**Re: Hot Spot Feasibility Study
New Bedford Harbor (891-01)
REVISED Review of Pilot
Dredging Study Report**

REVISED Review of Pilot Dredging Study Report,
September 8, 1989

NEW BEDFORD HARBOR
HOT SPOT FEASIBILITY STUDY
REVIEW OF REPORTS

DREDGING PILOT STUDY REPORT

Figure A-1, Ladder Swing Speed vs Resuspension Rate,
Cutterhead Dredge

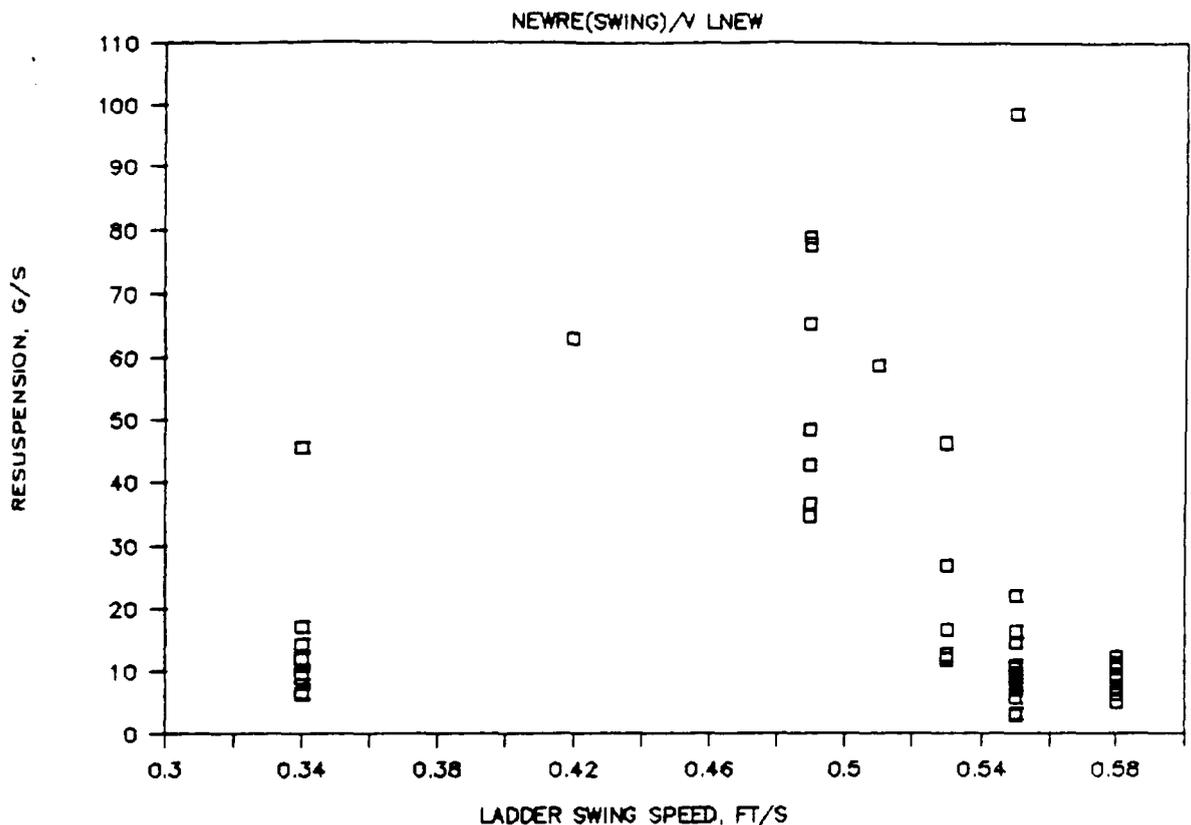
The average of the values for R in this table is 21.6 not 17.3. A plot of R vs ladder swing speed (S) values in Table A-1 is shown in Figure A-1 in the Appendix. This plot indicates no strong correlation between S and R. In fact one might conclude from these data that the lowest value for resuspension occurs with the highest ladder swing speed.

The average of the values for R in this table is 21.6 not 17.3 as indicated in the Report. A plot of R vs ladder swing speed (S) values in Table A-1 is shown in Figure A-1 in the Appendix. This plot indicates no strong correlation between S and R. In fact one might conclude from these data that the lowest value for resuspension occurs with the highest ladder swing speed.

The average of the values for R in this table is 21.6, not 17.3. A plot of R vs ladder swing speed (S) values in Table A-1 is shown in Figure A-1 in the Appendix. This plot indicates no strong correlation between S and R. In fact one might conclude from these data that the lowest value for resuspension occurs with the highest ladder swing speed.

The Report does not describe the sampling device or procedures used during this test. The sampling techniques are an important factor in the validity of this testing.

Figure A-2, Resuspension Rate vs Date of Observation
reference: Table 1, page 1-25 of Report

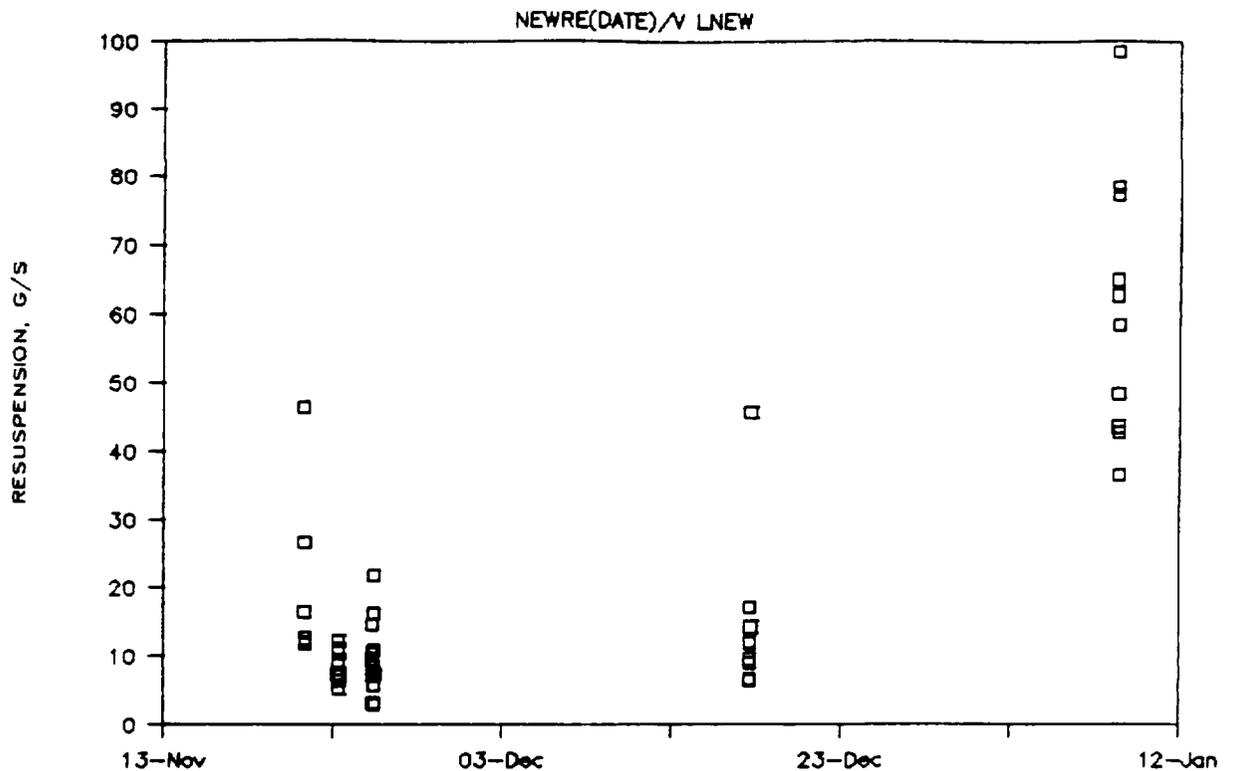
R values from Table A-1 are plotted vs date of observation in Figure A-2. This seems to indicate that the date of the observation is more significant than the ladder swing speed.

R values from Table A-1 are plotted vs date of observation in Figure A-2. This seems to indicate that the date of the observation is more significant than the ladder swing speed.

R values from Table A-1 are plotted vs date of observation in Figure A-2. This seems to indicate that the date of the observation is more significant than the ladder swing speed.

This plot indicates much higher resuspension for the last of the three test periods. Ladder swing speeds are reported to have varied from 0.42 to 0.55 ft/s during these observations with 7 of 10 observations at a swing speed of 0.49 ft/s. Comparison with Figure A-1 will show this value to be about at the midpoint of swing speeds tested.

Figure A-3, CDF, Weir and Effluent TSS,
2 - 30 December 1988

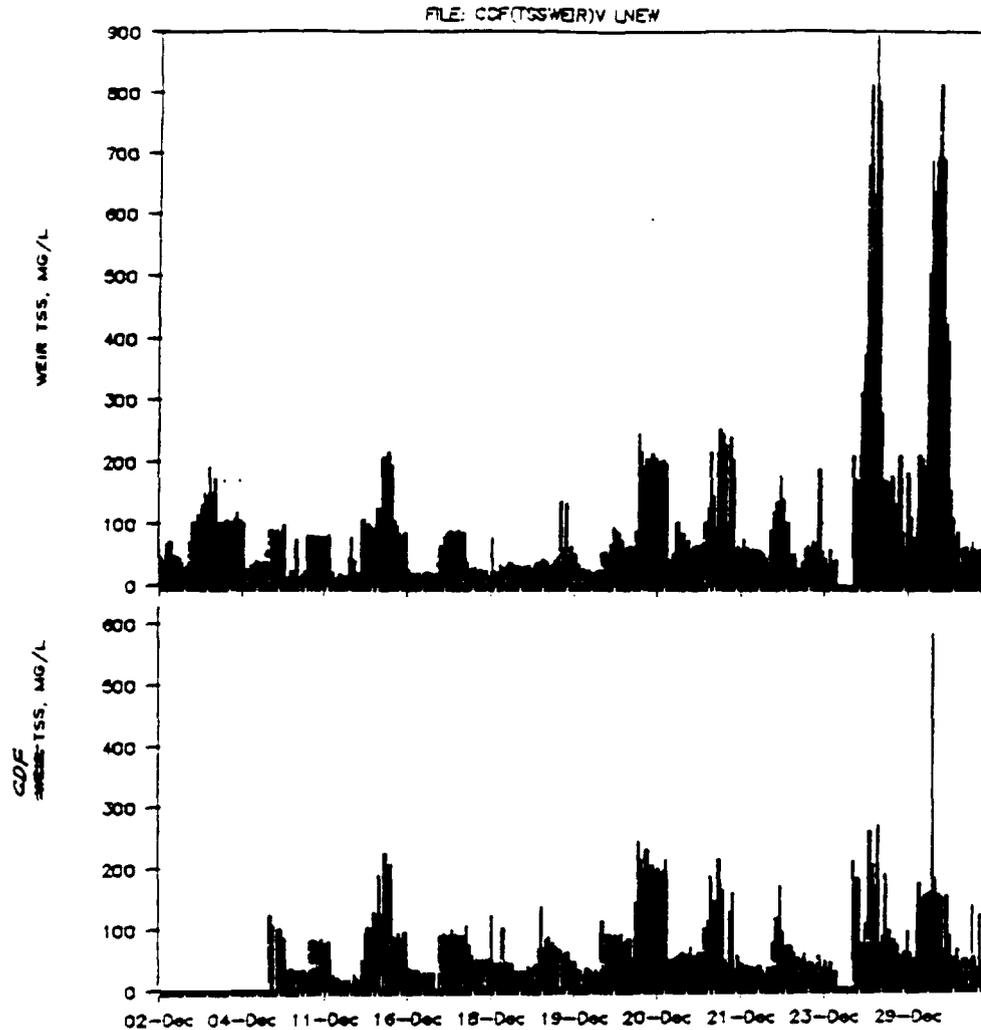
1988 are given in the Appendix, Table A-2 and Figure A-3. The plot shows a significant increase in TSS for 28 - 30 December when the CDF cap was being placed. Polymer addition was made during this period. Slurry solids concentrations were reported as about 150 g/L vs the 35 g/L typically carried during placement of contaminated materials. One would expect good performance (low TSS) even at this higher solids loading.

2.2.2 Secondary Cell - Polymer was added only during the placement of clean cap materials by spraying at the primary cell weir. The Report states that polymer addition had no effect at low slurry solids concentrations (see Figure A-3). At the high solids levels experienced there was a measurable effect. We make three general observations:

COMMENT - The CDF effluent TSS data are presented in Table 1, page 2-7 of the Report. These data and a plot of values for the period 2 December through 30 December 1988 are given in the Appendix, Table A-2 and Figure A-3. The plot shows a significant increase in TSS for 28 - 30 December. The CDF cap was being placed during this period. Slurry solids concentrations were reported as about 150 g/L vs the 35 g/L typically carried during placement of contaminated materials. One would expect good performance even at this higher solids loading. Possibly the fact that the CDF never attained the desired ponding depth of 2 ft due to the excessive leakage through the sheet pile dividing wall would explain this poor performance. For this reason the operational performance of the primary cell, and the polymer addition performance discussed below, are not conclusive.

COMMENT - Polymer was added only during the placement of clean cap materials by spraying at the primary cell weir. The data indicate polymer addition had no effect at low slurry solids concentrations (see Figure A-3). At the high solids levels experienced there was a measurable effect. We make three general observations:

Upper plot is the Primary Cell effluent TSS, lower the Secondary Cell effluent TSS. Polymer was added only during the placement of clean cap materials (20 - 30 Dec) by spraying at the primary cell weir.

Figure A-4, CAD Cross Sections

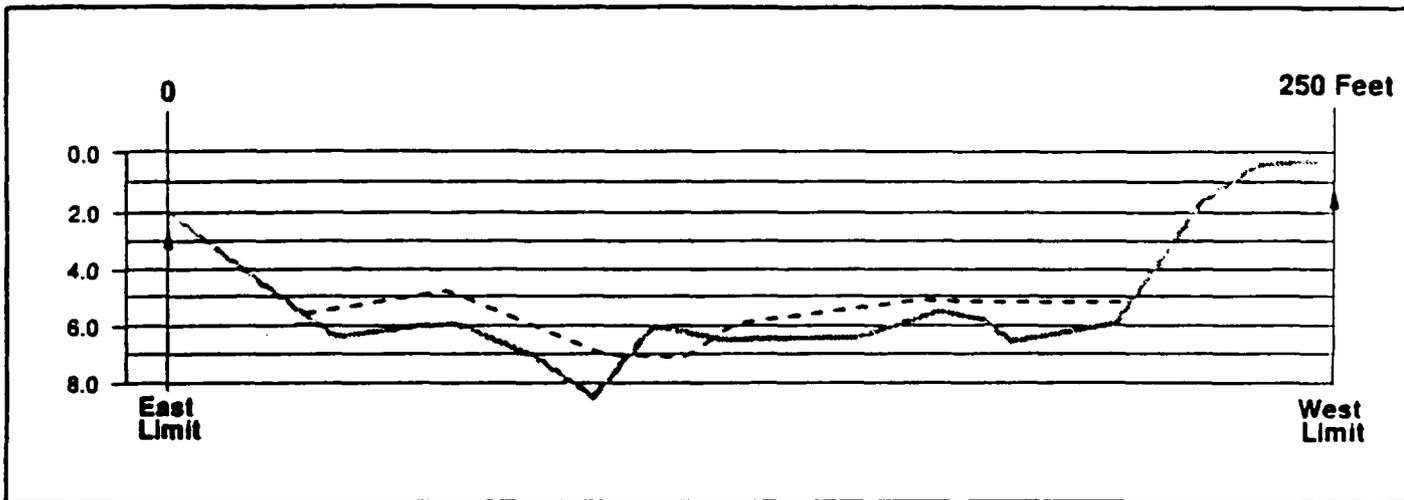
a. variations from what was apparently meant to be a level bottom. The after dredging bottom varied in elevation from -5.5 to - 8.5 ft, a difference of 3 ft. The after filling bottom varied from -4.8 to -7.1 ft, a difference of 2.5 ft (Report Figure 3-3, page 3-4). A 50 by 50 ft section at -8 ft was described but is not evident.

The performance of the CAD cell is not substantiated by the data presented in the Report. The cross section presented in Figure 3-3, page 3-4 of the Report does not indicate that a 2 to 3 ft cap was placed. This cross section is reproduced and discussed in Figure A-4 of the Appendix.

COMMENT - The one set of cross sections relating to the CAD development are presented in Figure 3-3, page 3-4 of the Report. These sections are not fully annotated. These sections do not confirm that a 2 to 3 ft cap has been placed in the CAD. They do not given detail on the before and after placement depths for the contaminated material. Additional comments on this section are given in item 2.

COMMENT - As indicated in Figure A-4, the cross section presented in the Report, Figure 3-3, does not demonstrate that that a cap of 2 to 3 ft thickness was placed over contaminated material.

COMMENT - The emphasis in the Pilot Study has been upon precision dredging but depths are given as average values. Examination of Figure 3-3, page 3-4 of the Report, shows that there is no 50 ft by 50 ft with an average depth of -8 ft mlw. The remaining portions of the cell bottom varied from about 0.5 ft above to 0.5 ft below the design grade of -6 ft. This is equivalent to a plus or minus 50 percent variation over the dredging cut of 1.1 ft expressed in the

This section is taken from Figure 3-3 of the Report. Although the section is not annotated, this is apparently a section in an East - West direction, transverse to the sections presented in Figure 3-2 of the Report. The Report refers to average depth of cut at the dredging areas but makes no indication of what tolerance should be expected in a hot spot or full scale project.

This section does not show the cap in place. The cap was placed five months before the date of the Report. This indicates an excessive lag between actual dredging or cap placement and the preparation of sections necessary for control of the project.
